Montana Department of Environmental Quality's Final Environmental Impact
Statement for Bull Mountain Development Company, LLC's Roundup Power
Project (Jan. 2002)

Roundup Power Project

Final Environmental Impact Statement

January 2003

Figure 3-7

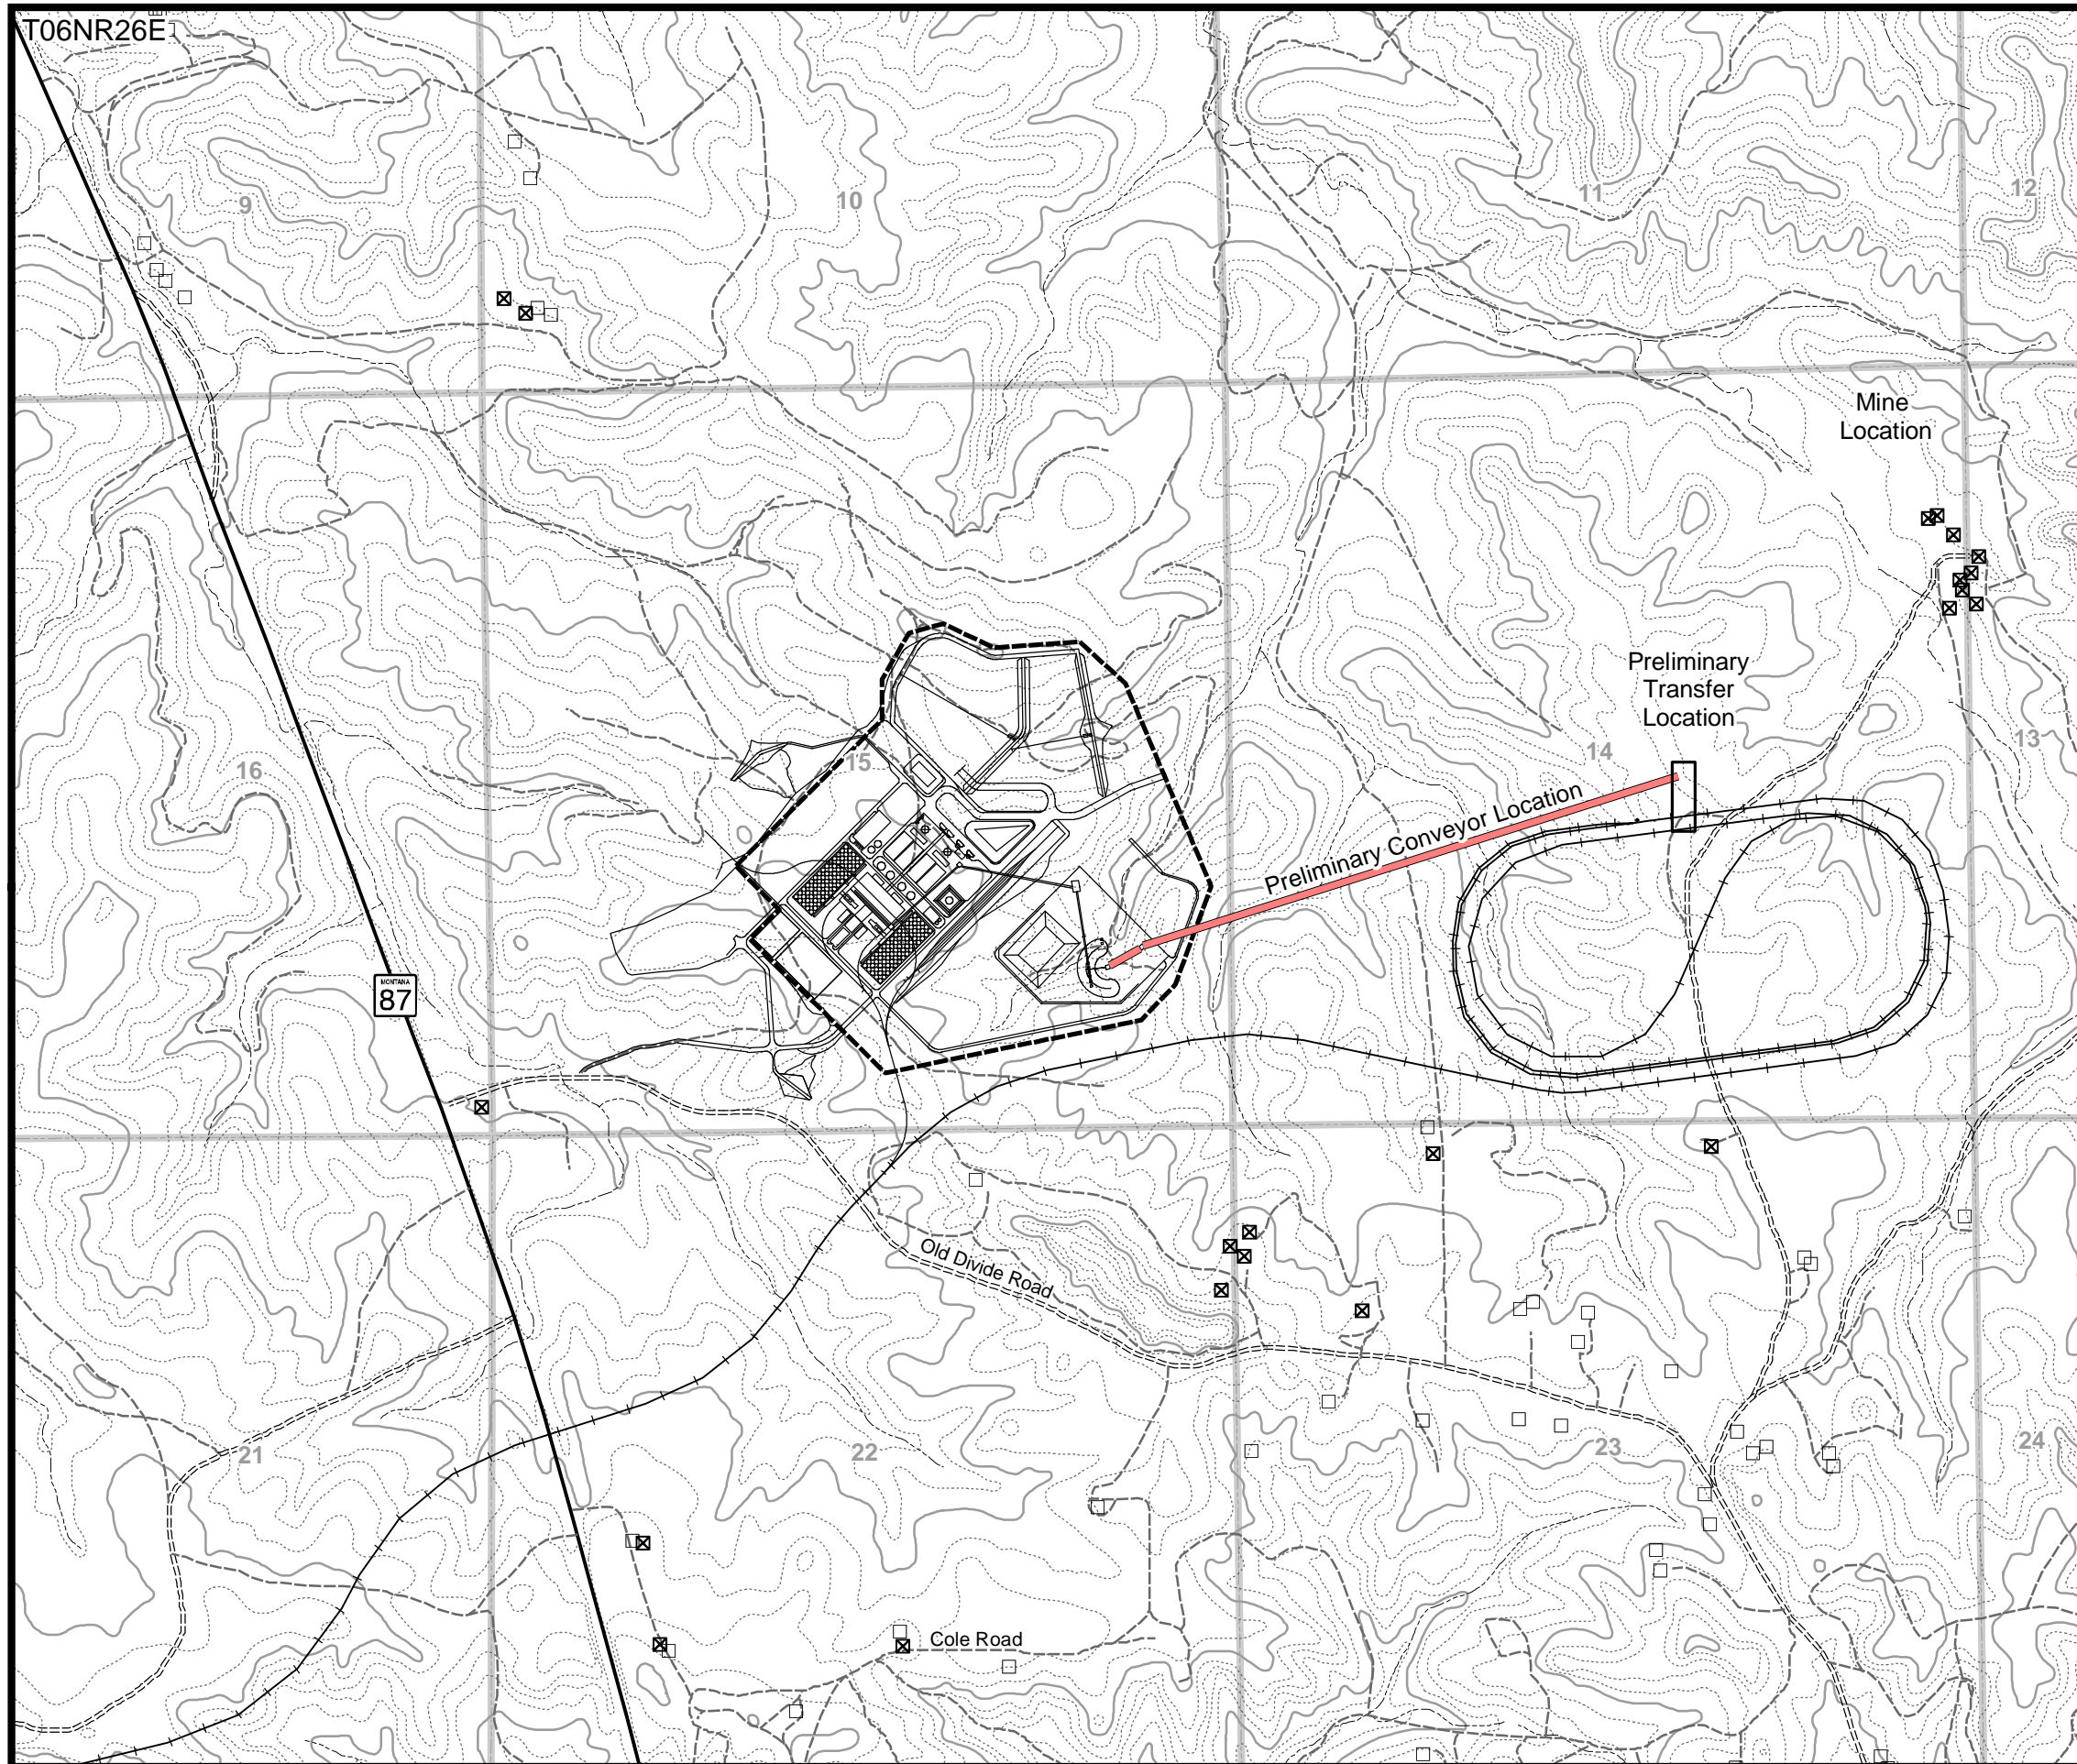
Page 3-55, Figure 3-7 Land Use, add label for Cole Road. See attached map at the end of this section.
